**SOLICITATION  
AMENDMENT**

<b>Title – Sujet</b> Stand Up Narrow Aisle Electric Double Reach Lift Truck		<b>Date</b> January 30, 2015
<b>Solicitation No. – N° de l'invitation</b> 201500306		<b>Amendment No. – N° de la modification</b> 001
<b>Client Reference No. - No. De Référence du Client</b> 201500306		
<b>Solicitation Closes – L'invitation prend fin</b>		
<b>At / à :</b>	2:00 PM	EST (Eastern Standard Time) HNE (heure normale de l'Est)
<b>On / le :</b>	February 9, 2015	
<b>F.O.B. – F.A.B</b>	<b>GST – TPS</b>	<b>Duty – Droits</b>
<b>Destination of Goods and Services – Destinations des biens et services</b> See herein — Voir aux présentes		
<b>Instructions</b> See herein — Voir aux présentes		
<b>Address Inquiries to – Adresser toute demande de renseignements à</b> Krista Meloche - Procurement Officer		
<b>Telephone No. – No. de téléphone</b> 613-843-3804		<b>Facsimile No. – No. de télécopieur</b> 613-825-0082

This amendment is raised to address the following:

Figure 4.1

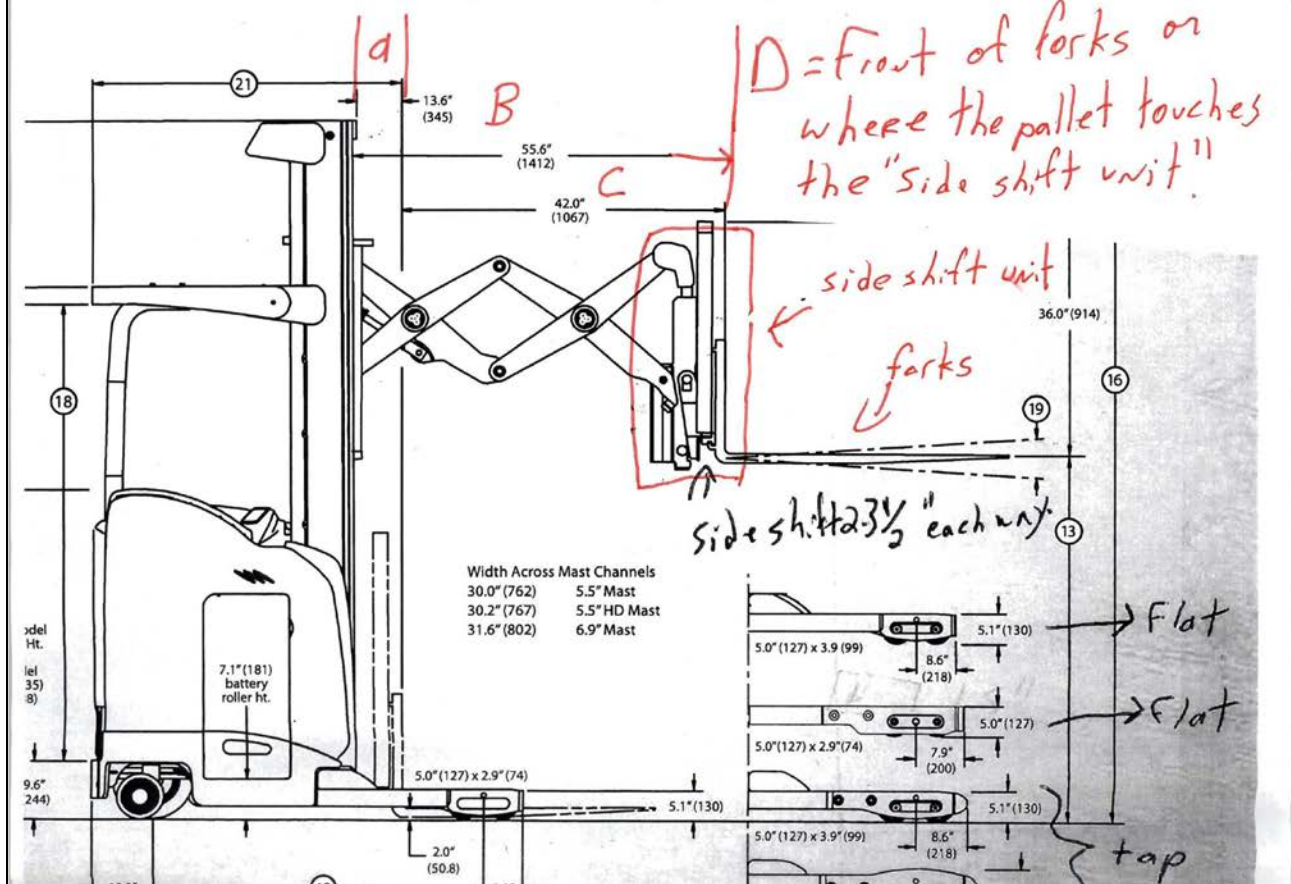
Please clarify the request for 72" when fully extended? Please clarify this dimension? From what point to what point of the truck requires this dimension? Please supply the depth to reach the second pallet?

Answer 4: RCMP need to reach into the double rack, to pick the pallet. We want the hydraulic movement side shift housing to extend at least 55" so we can reach into the second rack. Example picking pallet up in 2<sup>nd</sup> racking, when lifted the forklifts hydraulics need to have the ability to retract 55 inches or more.

If the forklift has no forks on the forklift the extending hydraulics/side shift housing would still need to extend to 55".

We are interested in 55" total extended distance

This means (A) the area the extension parts take up when fully retracted, counts for 13.6" of the 55" total. The real movement is about 42" (C) for the total of 55.6" (B).

The extended total distance ends at the front of the forks (D).

The final distance for full extension must be is 55" or greater. This is from fully retracted (A) to fully extended (D).

$13.6'' + 42'' = 55.6''$   
 $a + c = B$  (ability to place a pallet 55'' into the 2<sup>nd</sup> depth of racking)
